FiberTite Technical Bulletin #2015.002

Issue Date: October 22nd, 2015
Issued By: FiberTite Technical Services
Re: All FiberTite Membranes
Bridging Transitions

Roofing FiberTite® Across / Through Slope Transitions and Changes in Plane

REVISES DETAIL	ISSUE DATE	DRAWING NUMBER
ALL PREVIOUS	11/05/15	FTR-ST1

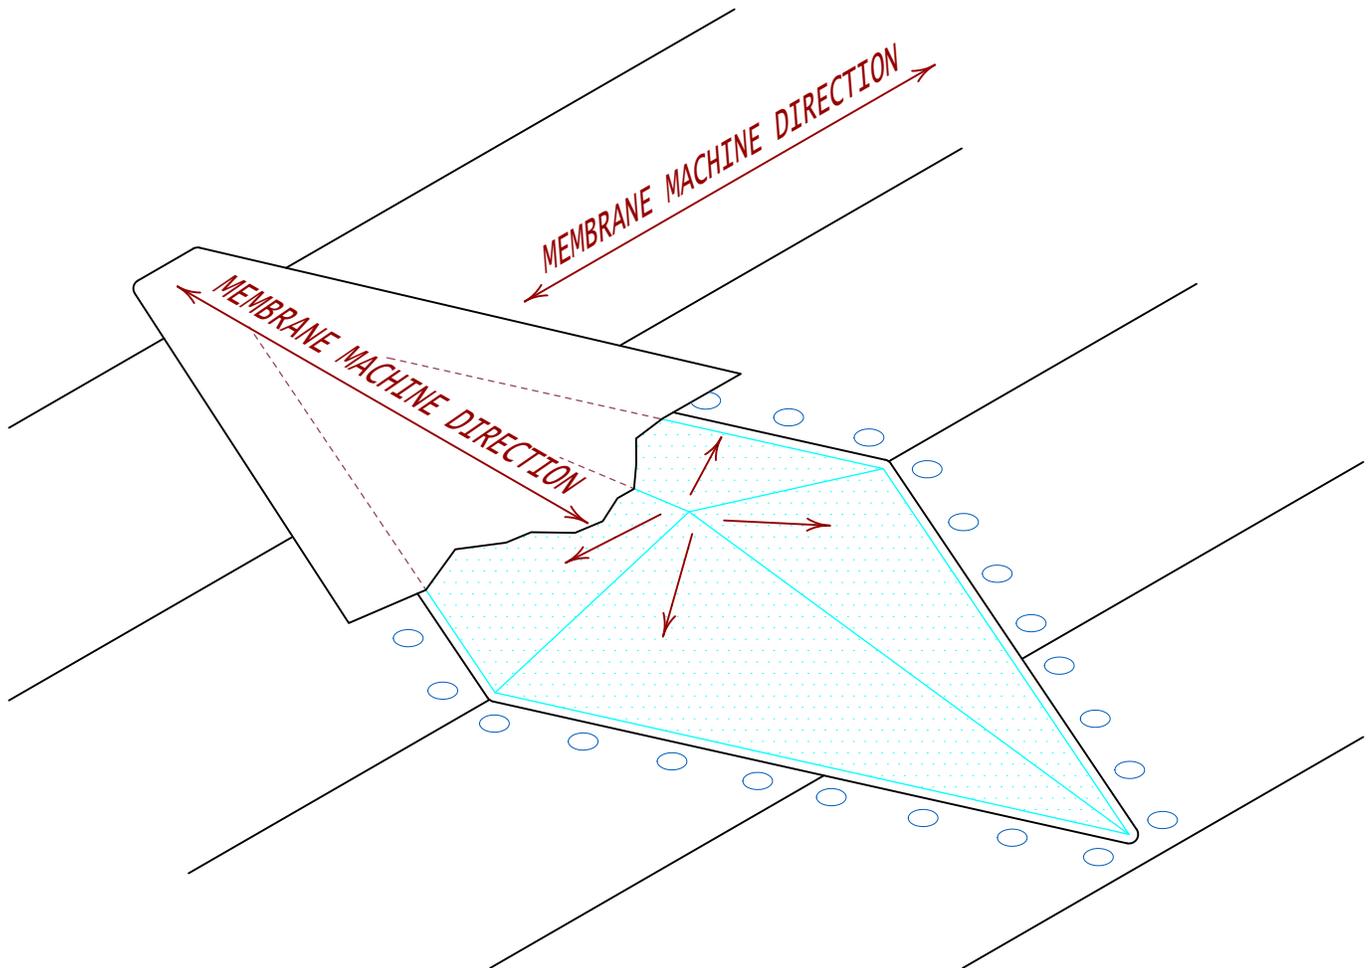
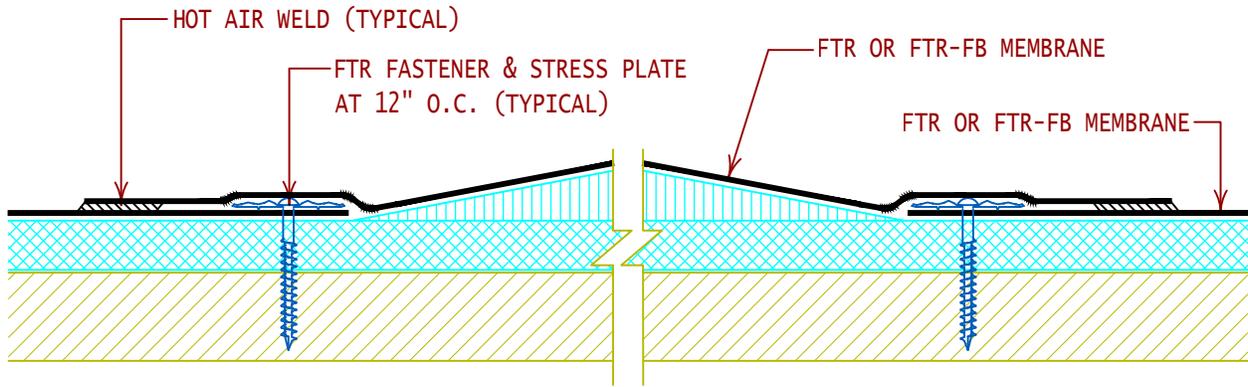
Seaman Corporation requires that all **FiberTite Roofing Systems** be mechanically attached at all transitions in plane / slope greater than a +1/4-in per linear foot. Failure to restrain the membrane at these transitions may induce bridging of the membrane. The possibility of bridging is increased when the machine direction of the membrane runs perpendicular to the slope transition.

NOTE: ROOFING SYSTEMS SHALL BE MECHANICALLY ATTACHED AT ALL TRANSITIONS IN PLANE/SLOPE GREATER THAN 1/4" PER LINEAR FOOT TO ELIMINATE POTENTIAL BRIDGING OF THE MEMBRANE.

REVISES DETAIL	ISSUE DATE	DRAWING NUMBER
ALL PREVIOUS	11/05/15	FTR-ST2

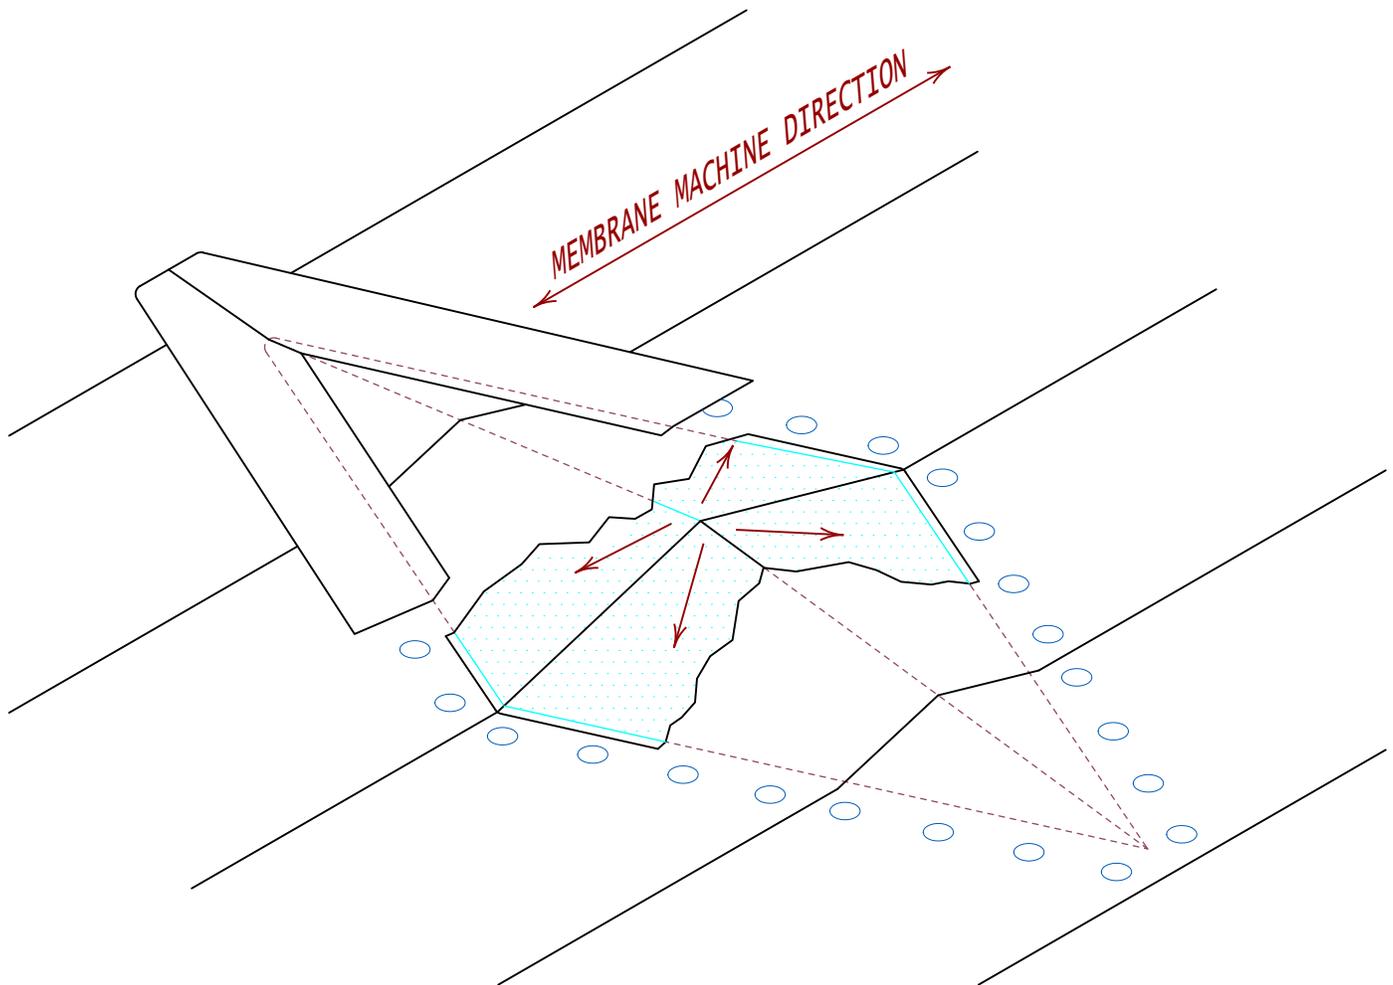
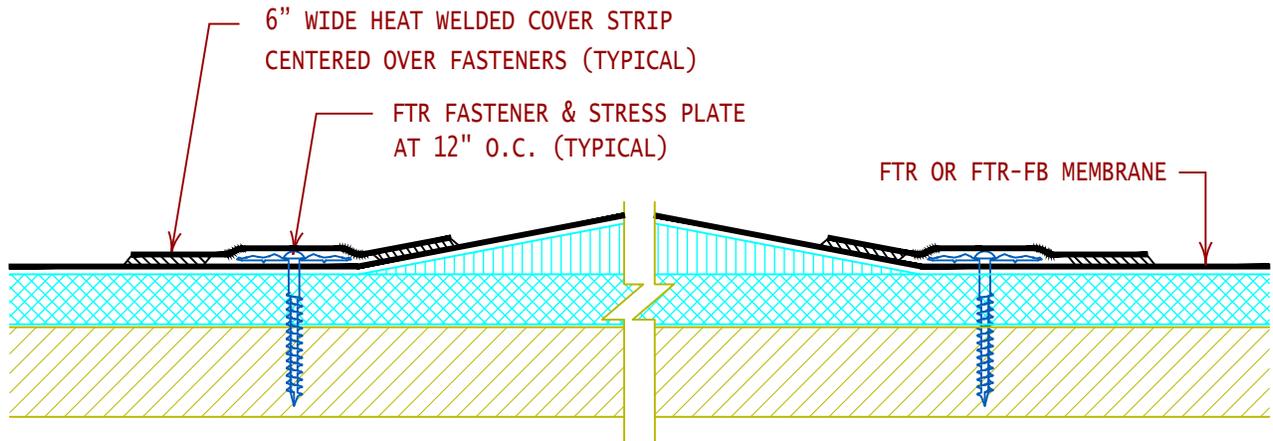
NOTE: ROOFING SYSTEMS SHALL BE MECHANICALLY ATTACHED AT ALL TRANSITIONS IN PLANE/SLOPE GREATER THAN 1/4" PER LINEAR FOOT TO ELIMINATE POTENTIAL BRIDGING OF THE MEMBRANE.
